REQUEST

Current Zoning: R-5 AIR (single family residential, Airport Noise Overlay), B-2 AIR (general business, Airport Noise Overlay)
Proposed Zoning: UR-2(CD) AIR (urban residential, conditional, Airport Noise Overlay)

Approximately 7.7 acres located on Tennyson Drive near Interstate 85.

The petition proposes to allow 38 single family attached residential dwelling units on a vacant site in the Enderly Park neighborhood.

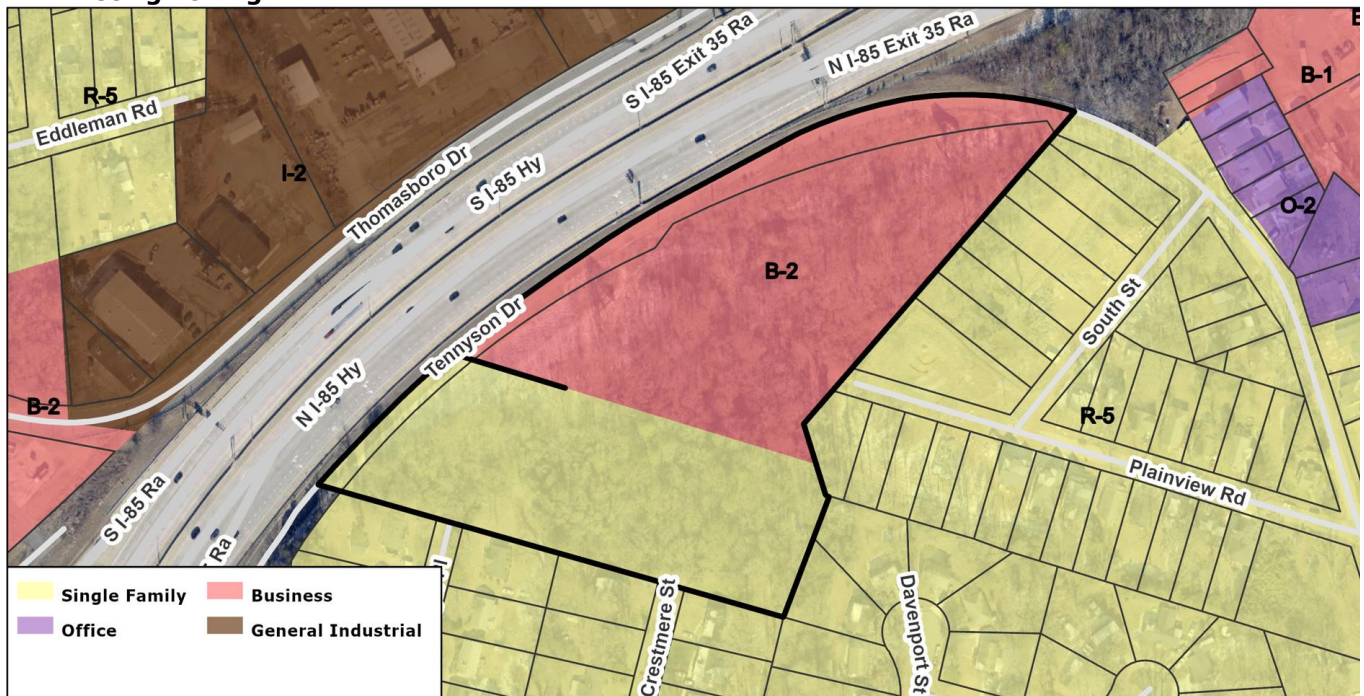
1. Add "AIR" to both the existing and proposed zoning on site plan. This site is within the Airport Noise Overlay, abbreviated as "AIR".

2. Revise roadway design to remove 90 degree turn and satisfy CDOT standards for public roadway geometry.
